Subject: VIRGIL C. SUMMER NUCLEAR STATION
DOCKET NO. 50/395
TECHNICAL SPECIFICATION AMENDMENT REQUEST - TSP 99-0090
SPENT FUEL POOL STORAGE EXPANSION - SUPPLEMENTAL LETTER -
RESPONSE TO RAI DATED JUNE 20, 2002

Attachment I
Responses to Request for Additional Information

Figure 1 Temporary Crane Outline

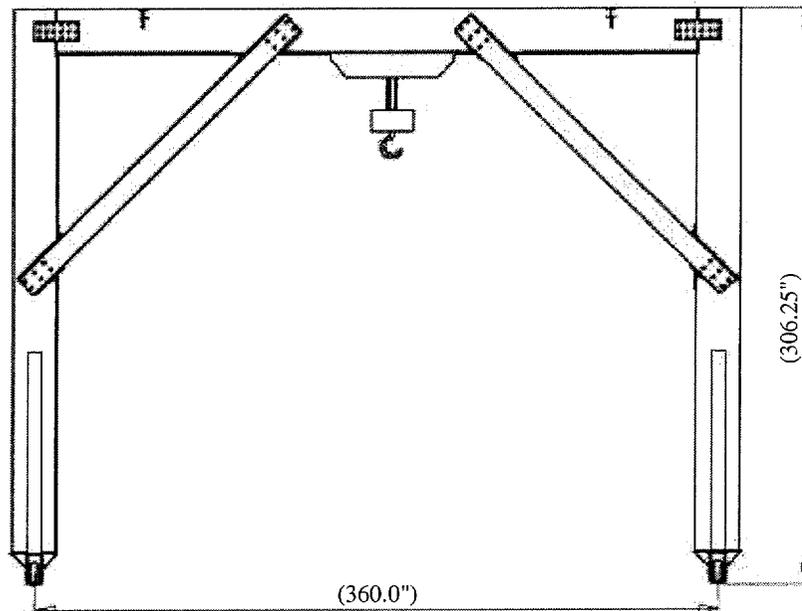
- (1) Neither Section 3 nor Section 10 of Attachment V to the amendment request provides a substantive description of the temporary gantry crane proposed for use in the rack replacement evolution. Describe key characteristics of the temporary gantry crane that will be used to install and remove racks from the spent fuel pool. At a minimum, this description should include the crane's rated capacity, how and where it will be mounted on the operating floor, its range of travel, and any special design features that reduce the risk of load drops due to mechanical failures, load hangups, and "two-blocking" events.**

The 40,000 lbf rated temporary crane is needed to load and unload new and existing spent fuel racks from the spent fuel pool because the existing SCE&G Fuel Handling Building overhead crane cannot reach over the spent fuel pool. The temporary crane travels on the existing spent fuel handling bridge crane rails under its own power. The travel of the temporary crane covers the entire length of the rails in the east-west direction from the spent fuel pool to the decontamination and new fuel storage areas. There are existing mechanical bumpers at each end of the rails preventing the temporary crane from traveling beyond the limits of the rails. The trolley travels the entire width of the pool in the north-south direction. The temporary crane will be erected in the decontamination pit area at the east end of the Fuel Handling Building away from the Spent Fuel Pool.

The temporary crane is considered to be a non-safety related structure. However, it travels over safety related equipment and fuel. Therefore, the design has been analyzed to preclude any load drop or crane damage resulting in uncontrolled lowering of any portion of the crane into the pool. The crane has overall dimensions as shown in Figure 1 and weighs 30,500 lbf.

The hoist is rated for 37 ½ metric tons and selected to conform to CMAA-70 (2000). The hoist and its brake are rated such that it maintains a 10:1 safety factor in order to meet the requirements stipulated in section 5.1.6 (3)(b) of NUREG-0612. The load holding brakes comply with items 4.9.1.1 through 4.9.1.4 of section 4.9 of CMAA-70 (2000). The hoist braking system shuts off in the closed braking position upon loss of power. In the case of a failed braking system, pendant controls can be used to activate the hoist motor in order to control the load until safely landed. The hoist has upper and lower electric limits preventing two blocking events.
